Harvard Apartments
Project # : 3008933
Architect : Architecture Associates
Developer : WRP Associates
Planner : Lisa Rutzick

EDG Response Notes

Requested Departures

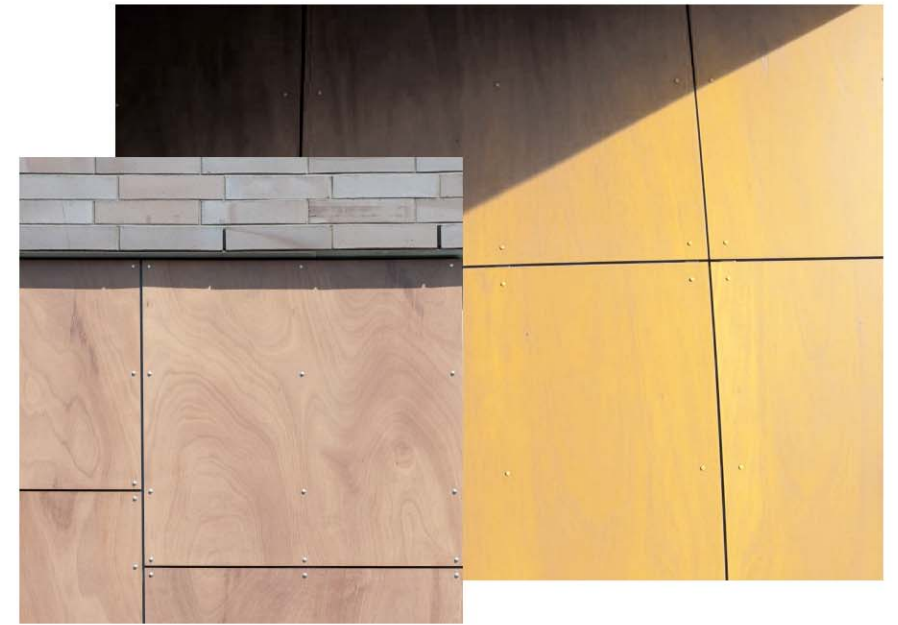
C-2 A redesign of the façade at L-1 and L-2 speak to the urban character of this neighborhood by enhancing and extending the commercial store-front, L-2 terrace adds connection to the street by providing human scale (tenants on terraces, etc) above grade. Space has also been allocated for outdoor seating should commercial tenant so desire. Overhead protection extends nearly the entire façade.

West elevation at Street Level

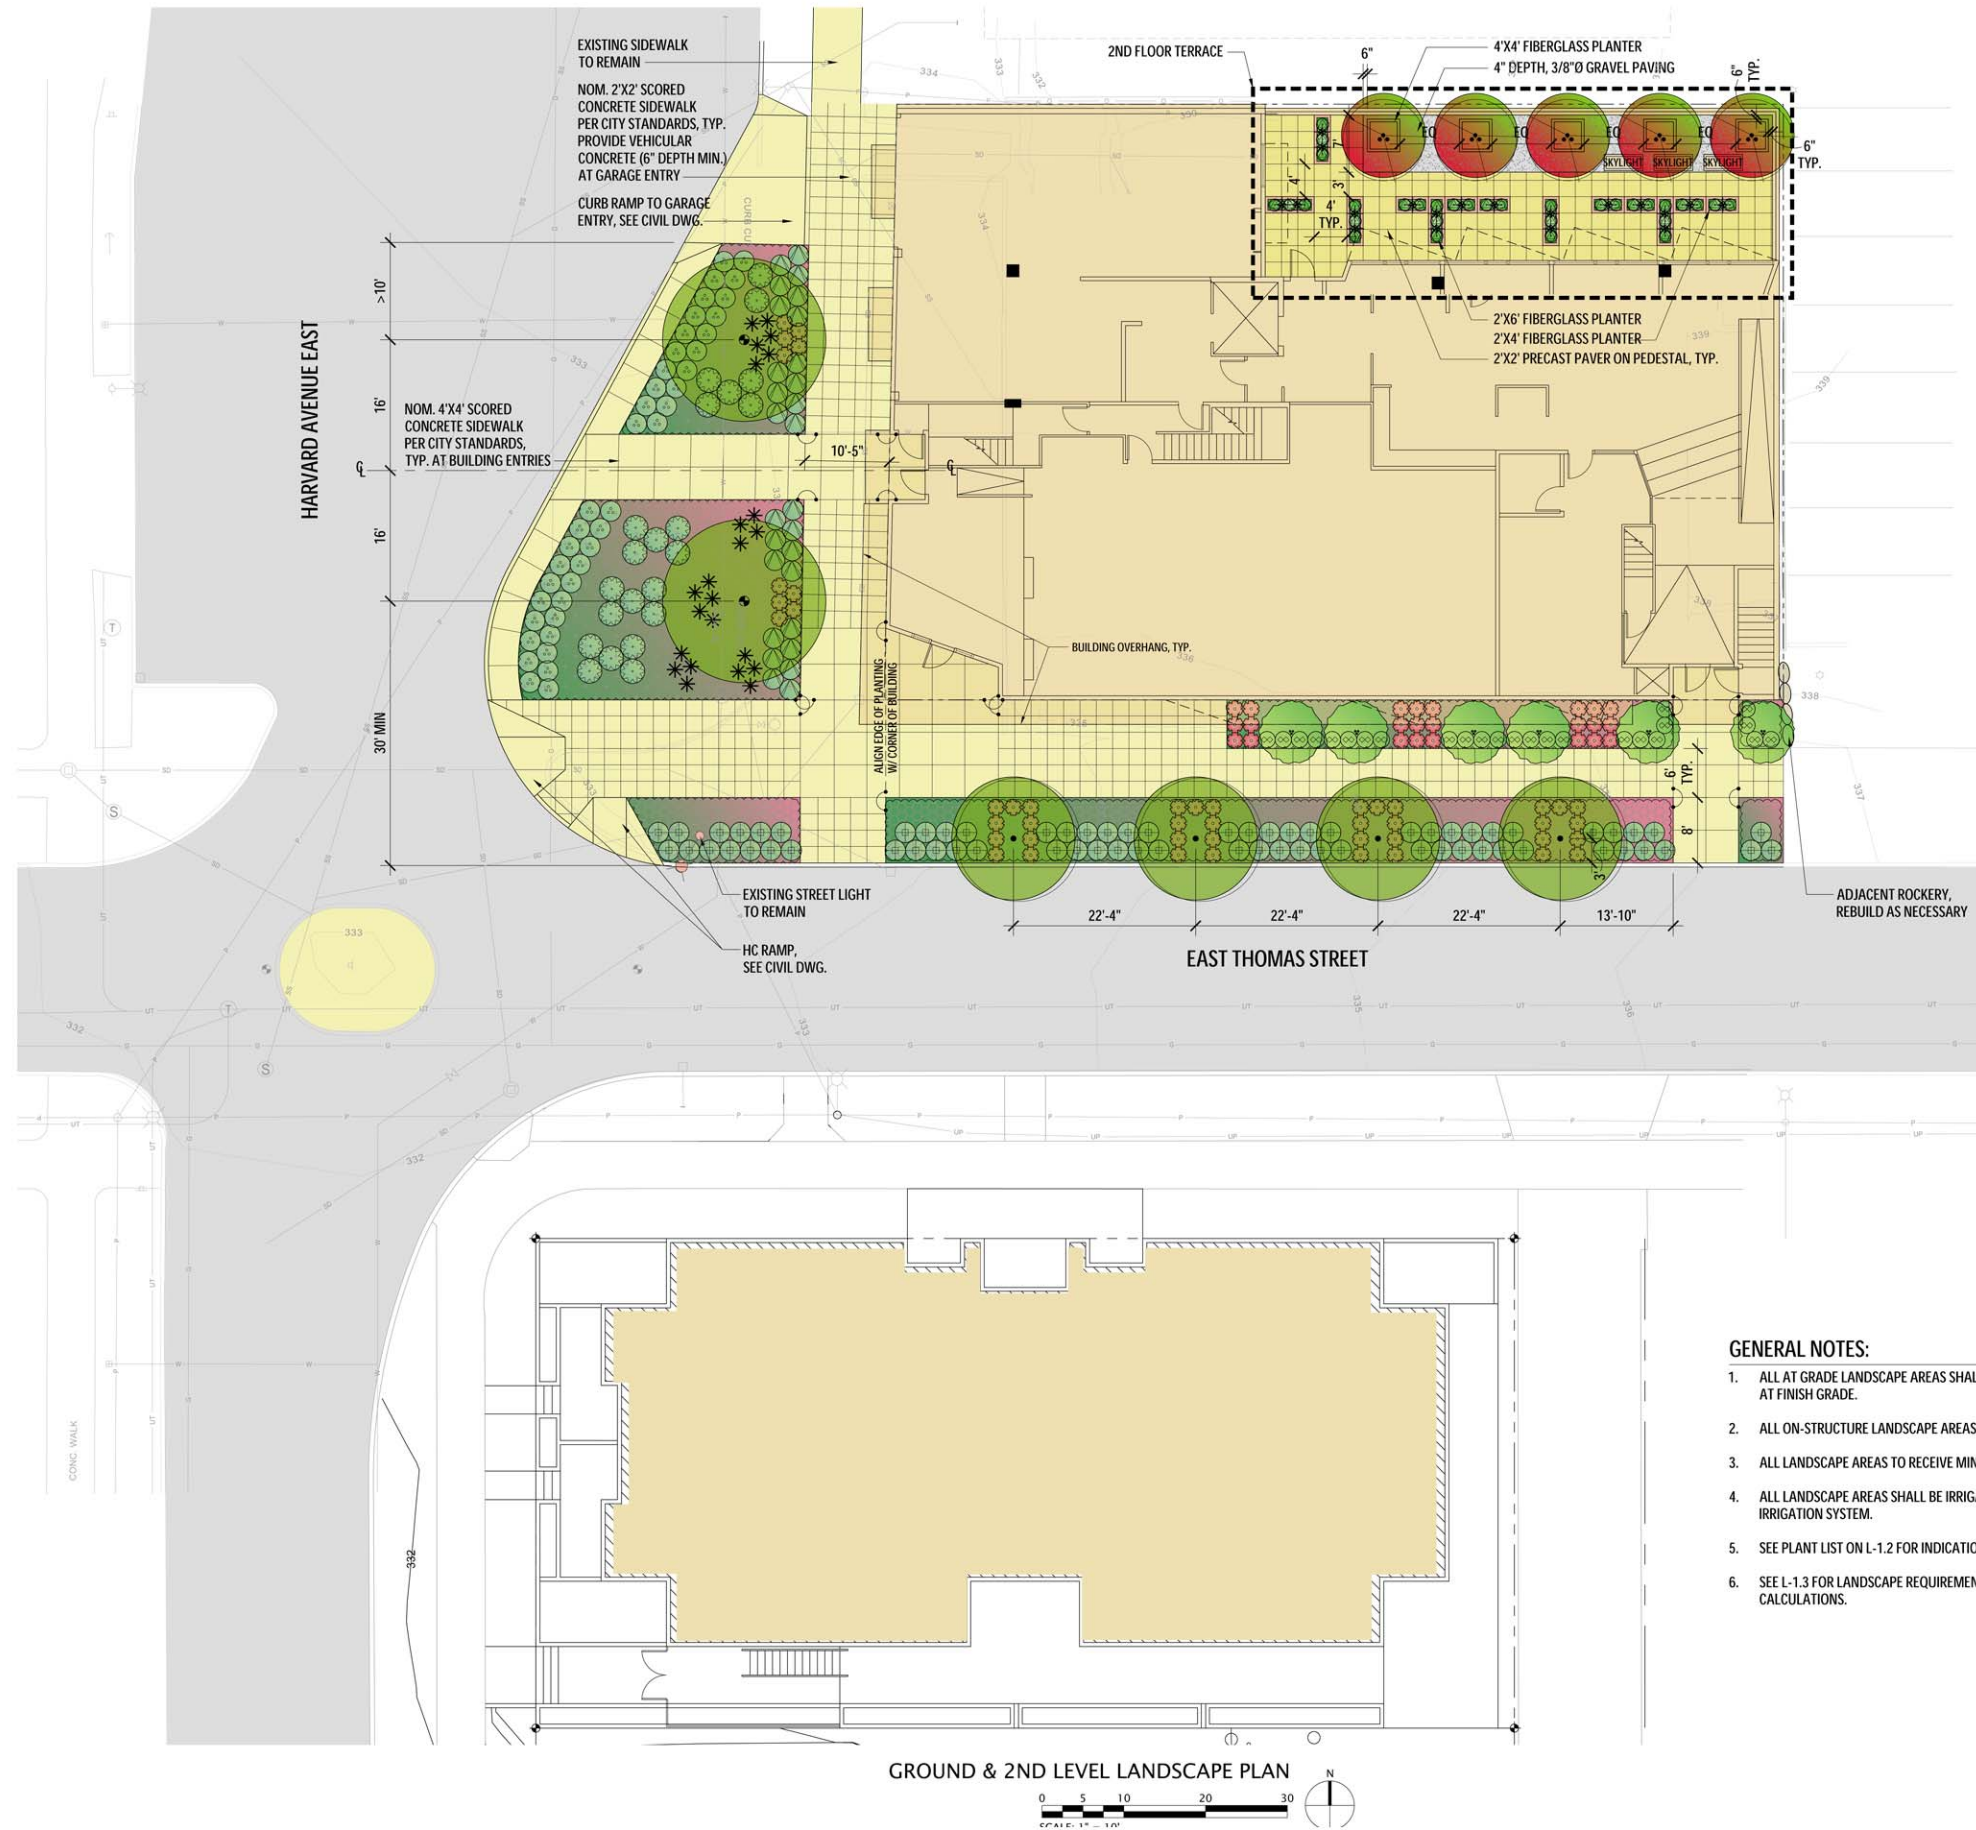
Transparency SMC 23.47A.008.2

Requirement: 60% of the street facing facade 2' and 8' above the sidewalk shall be transparent.

Request: 49% of the west facade is transparent (including the garage door). The non-transparent walls are necessary structural shear walls.

Board Response: New Request.

Sight Triangle SMC 23.54.030.G

Requirement: 15' sight triangle at garage exit

Request: Eliminate sight triangle

Board Response: Board supportive of adjustment to sight triangle requirements provided that other measures, such as mirrors and traffic indicators are used to promote pedestrian safety.

Solution: In an attempt to respond to the intent of the code in providing a dynamic pedestrian experience we propose to cover the shear walls with alternating foliage and art. (see rendering below)

Solution: A 15' sight triangle is not provided. Mirrors and traffic indicators will be utilized to increase pedestrian safety. The North neighbor's driveway abuts the North property line and allows for an existing unobstructed view at the proposed garage entry. (see diagram below)
